**STATE OF TENNESSEE  
DEPARTMENT OF TRANSPORTATION  
DESIGN DIVISION**

**INSTRUCTIONAL BULLETIN NO. 13-08**

**Regarding New and Revised Standard Drawings**

**Effective for the July 12<sup>th</sup> letting (May 1<sup>st</sup> turn-in),** the following Standard Drawings are new or revised and Section V of the Design Guidelines is revised for this update.

**ROADWAY CROSSING**

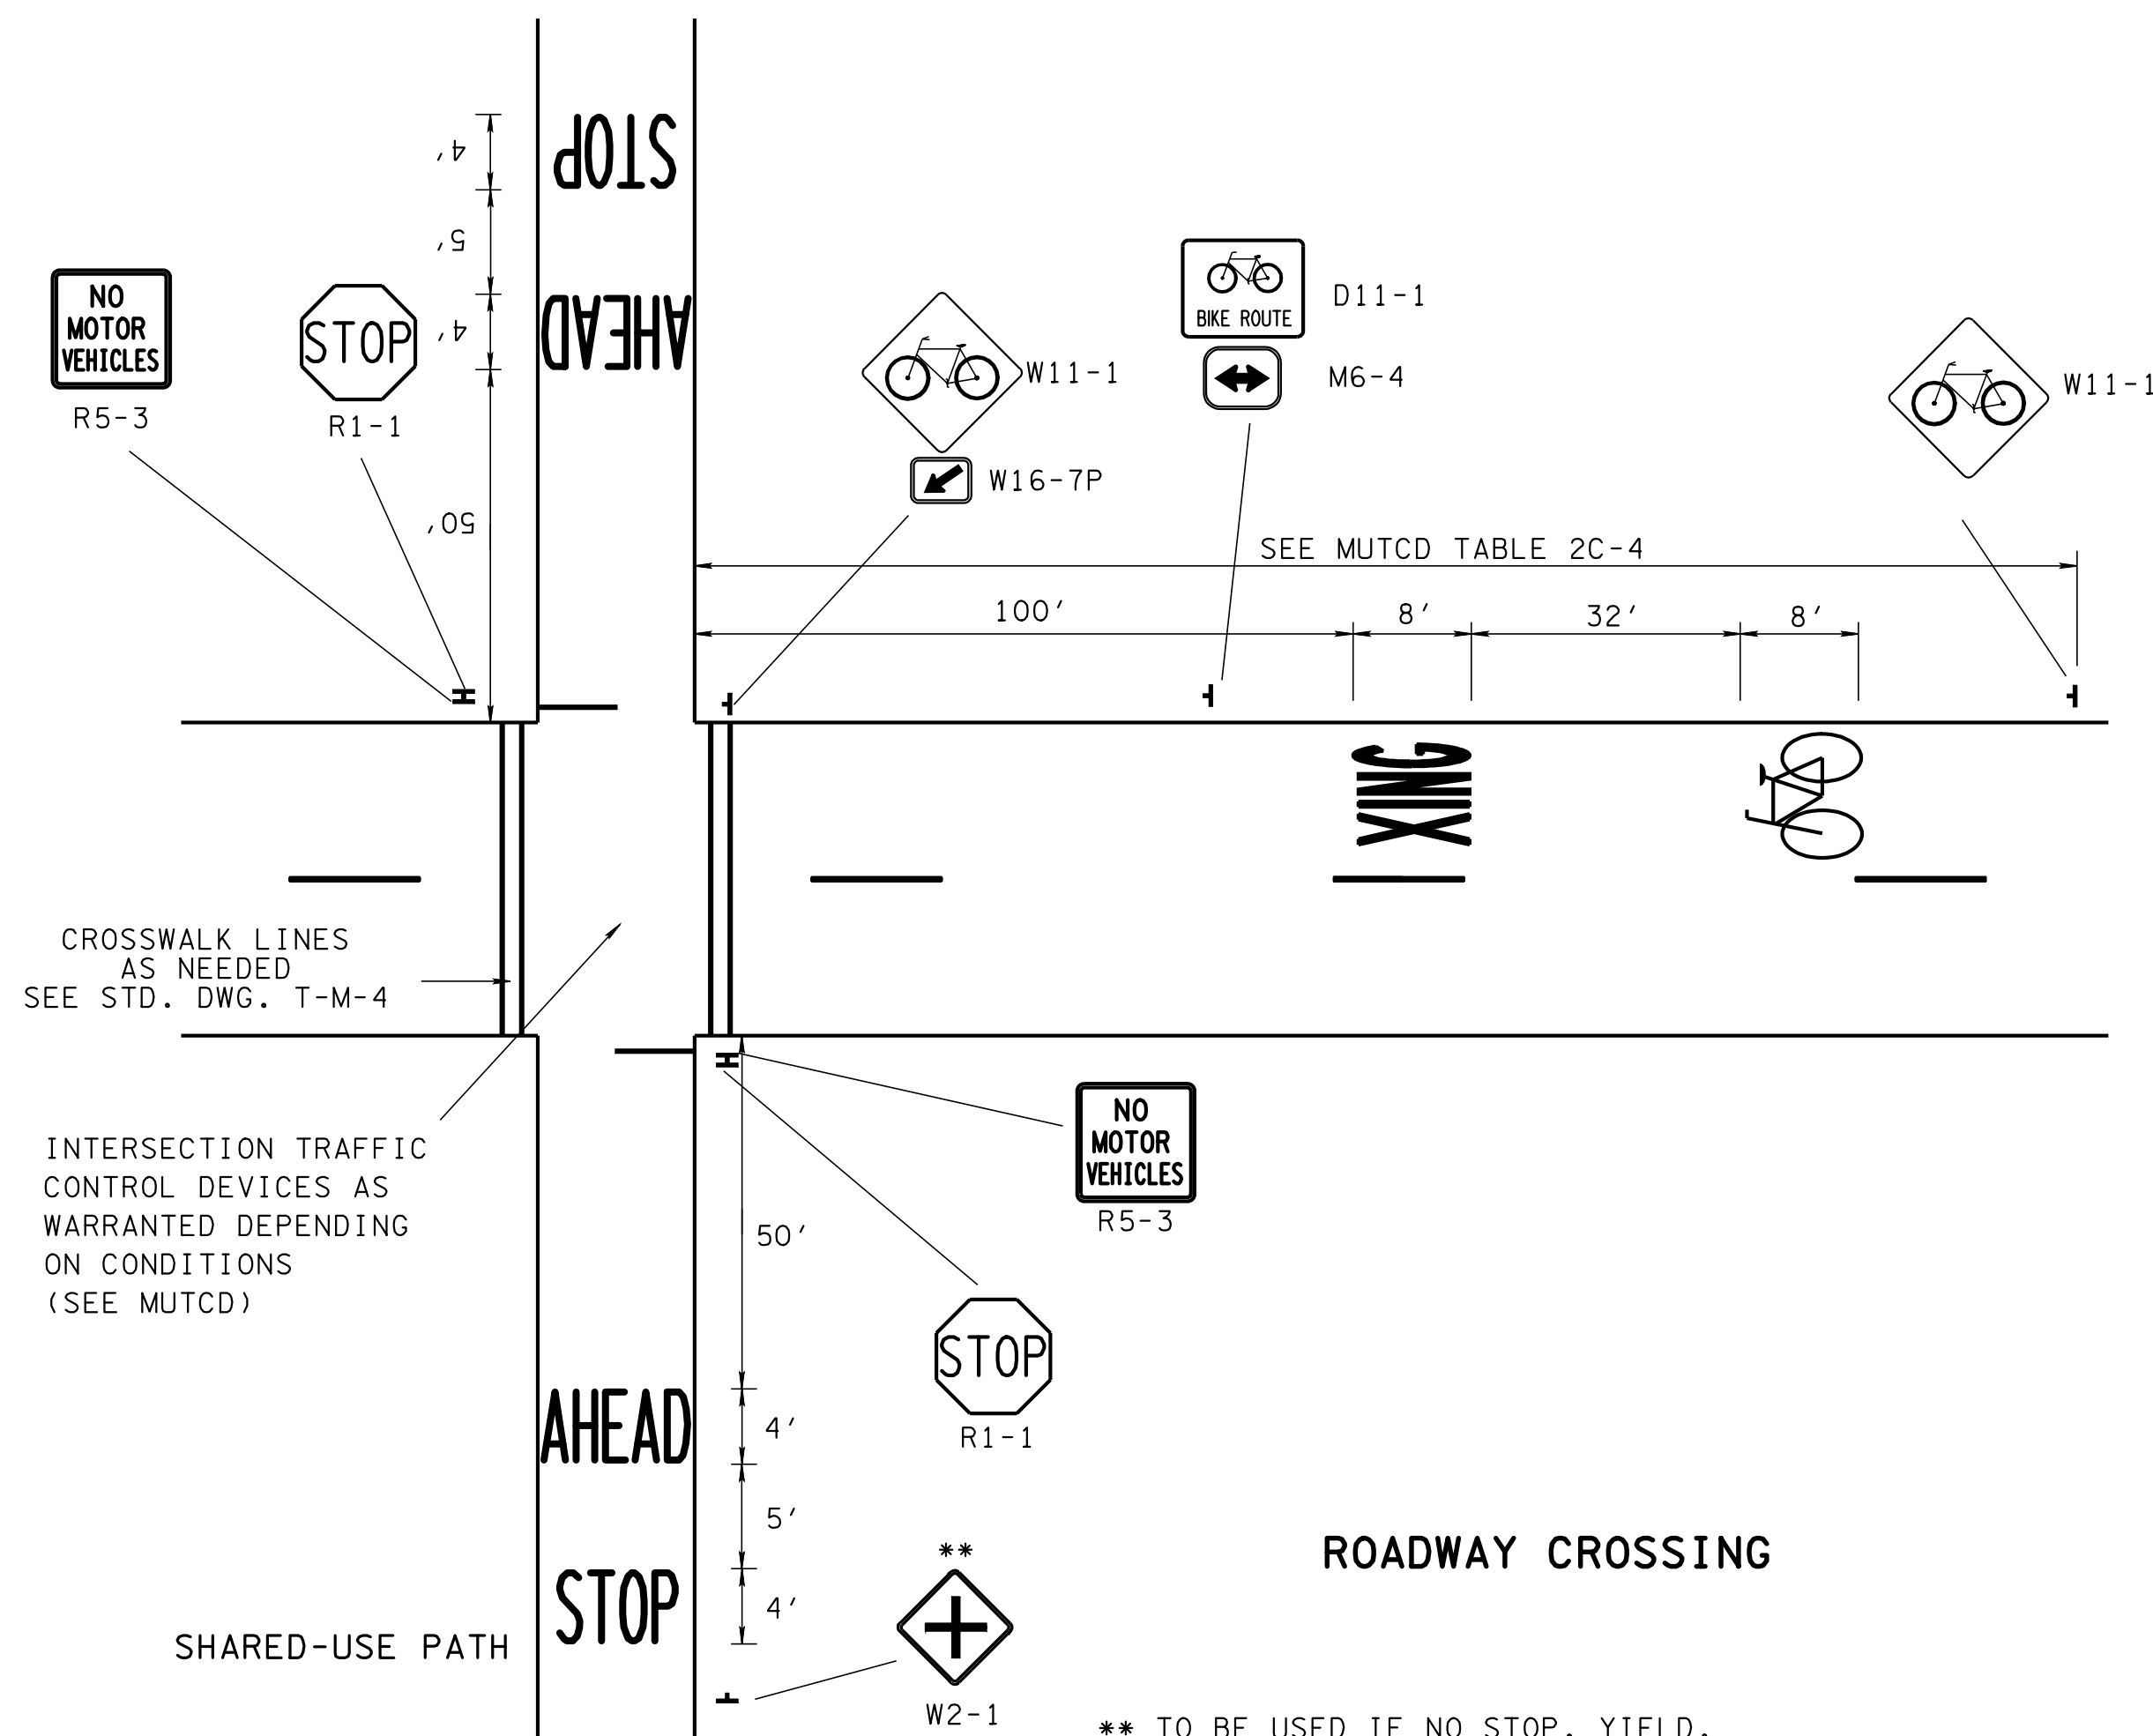
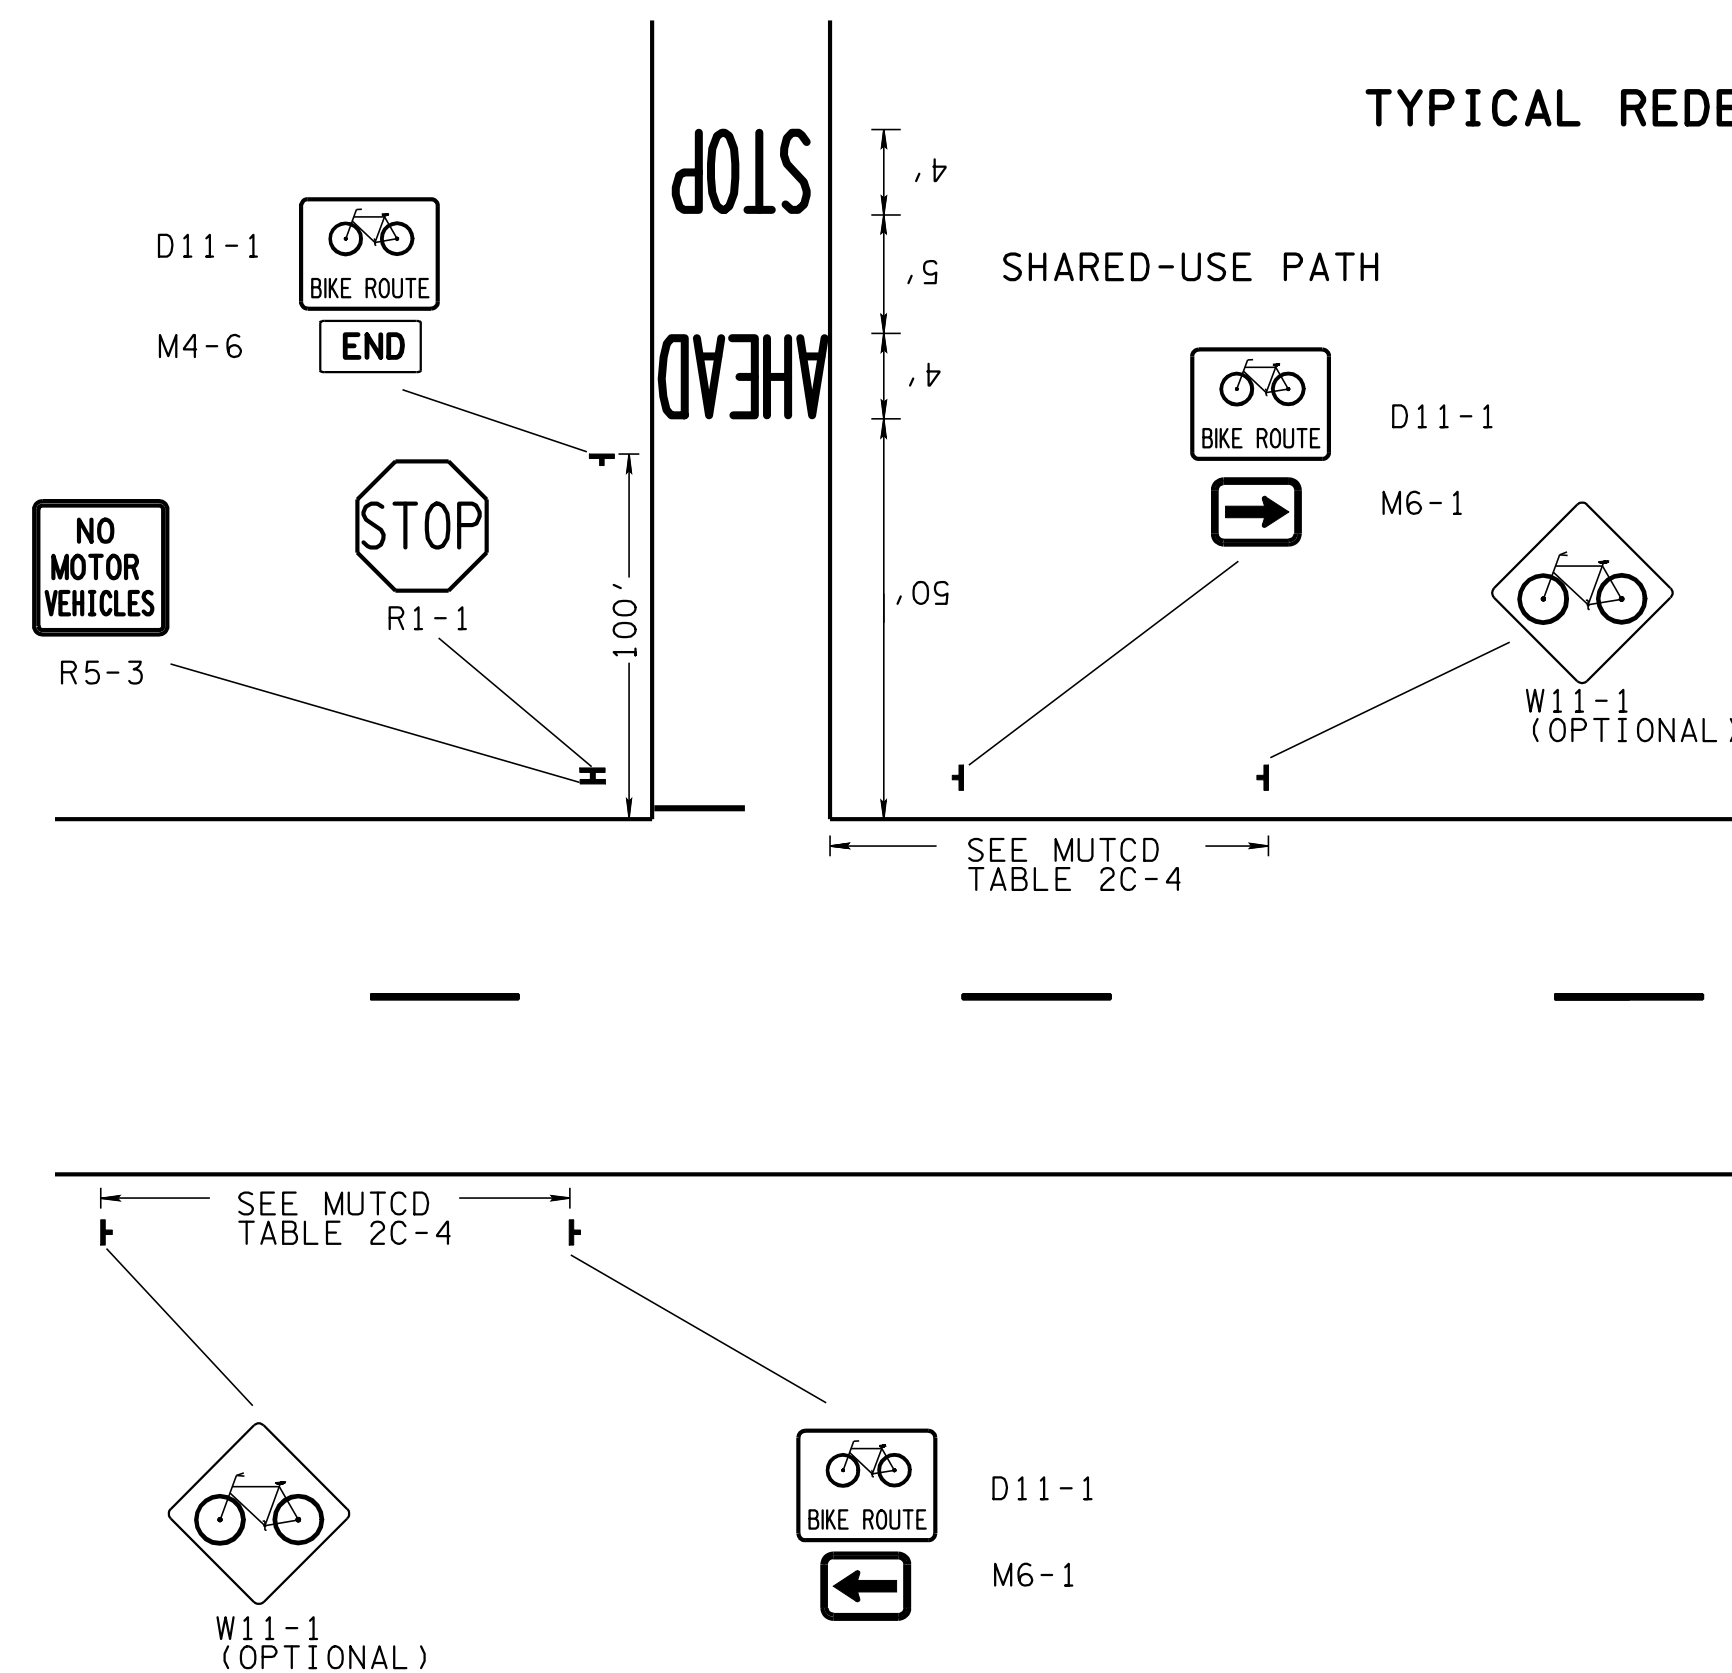
REV. 6-15-12: REVISED INTERSECTION SIGNING FOR 2012 EDITION OF GUIDE FOR THE DEVELOPMENT OF BICYCLE FACILITIES.
